# **Mute audio issue during downloading configuration file**

(KX-TGP series)

No. 04-003

March 3 , 2011

KX-TGP550T04

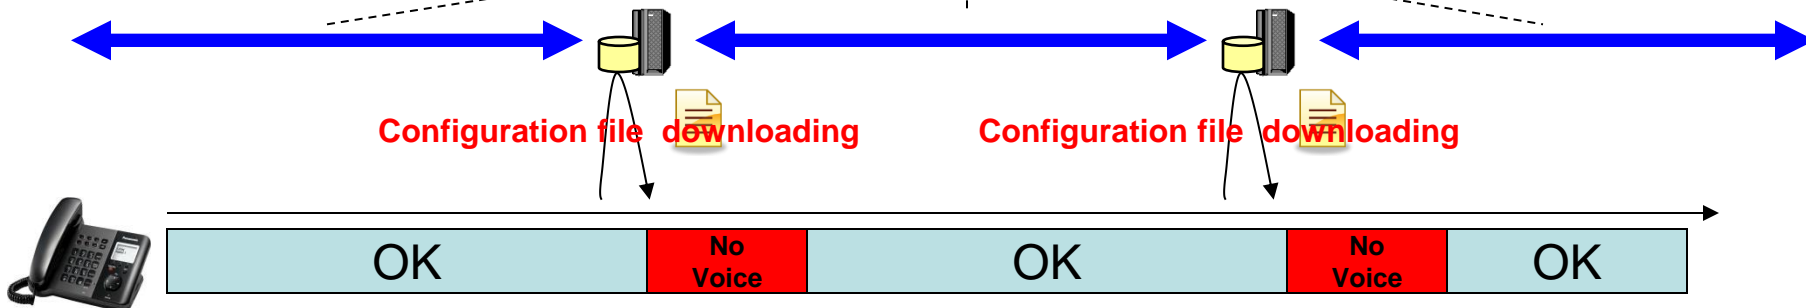
This happens only at the time when TGP is downloading configuration file while the line is in use for conversation.

Interval period of downloading

TGP has the setting of a specific time of downloading a configuration file in version 12.02 or later. Please configure it to an appropriate time when a call rarely happen. ( like midnight, "03:00")

Panasonic Corporation will provide the new Firmware version 12.10/22.10 with the fix. Please upgrade your phone's Firmware.
